Access Compliance Report

Public Rights-of-Way

(Curb Ramps)

Intersection ID: 29729	Main Street: TOM_SHORT_RD	Cross Street: KING_ARTHUR_DR	Location: SE
ADA ID: 2F825189F2DA	Ramp Type: PerpDiag	Initial Pass/Fail: Fail	Overall Compliance: No
Severity Score: 43.75			
Codes/Mitigation Info/Possible Solution		Field Measurements/Component Compliance

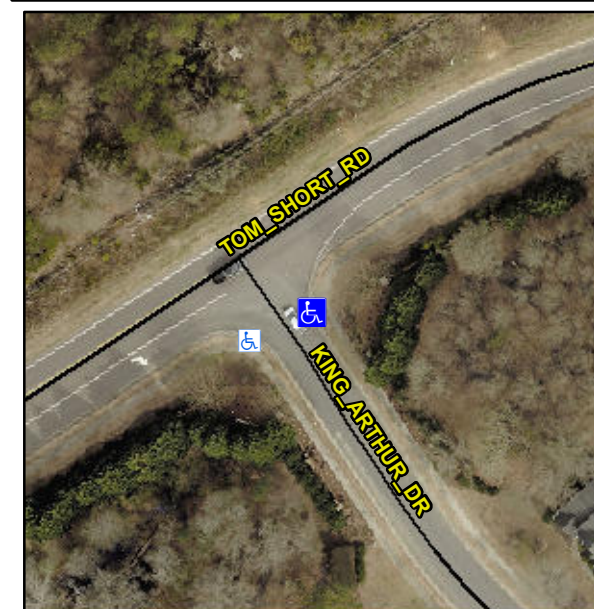
Not Found, R304.5.1, R304.2.2, R304.5.3

Compliance	Description	Data	Compliance	Description	Data
N/A	Ramp Length (in)	48.0	No	Ramp Slope (%)	12.6
No	Ramp Width (in)	35.5	No	Ramp XSlope (%)	4.8
N/A	Flare Type LT	N/A	N/A	Flare Type RT	N/A
N/A	Flare Slope LT (%)	N/A	N/A	Flare Slope RT (%)	N/A
N/A	Flare Traversable LT?	N/A	N/A	Flare Traversable RT?	N/A
N/A	Landing Length (in)	N/A	N/A	DWS Provided?	N/A
N/A	Landing Width (in)	N/A	N/A	DWS Contrast?	N/A
N/A	Landing Slope (%)	N/A	N/A	DWS Length (in)	N/A
N/A	Landing X Slope (%)	N/A	N/A	DWS Full Width?	N/A
N/A	Landing Curb? (Y/N)	N/A	N/A	DWS Offset (in)	N/A
N/A	Shared Landing?	N/A			
N/A	Gutter Ponding?	N/A	N/A	Gutter Slope (%)	N/A
N/A	Gutter Lip Ht (in)	N/A	N/A	Gutter X Slope (%)	N/A
N/A	Painted X Walk1?	No	N/A	Painted X Walk2?	No
	X Walk 1 Direction	To N		X Walk 2 Direction	To W
N/A	X Walk 1 Width (in)	N/A	N/A	X Walk 2 Width (in)	N/A
	X Walk 1 Slope (%)	4.7		X Walk 2 Slope (%)	5.4
	X Walk 1 X Slope (%)	4.6		X Walk 2 X Slope (%)	3.9

Remove & Replace Curb Ramp With Two New Directional Ramps or Equivalent.
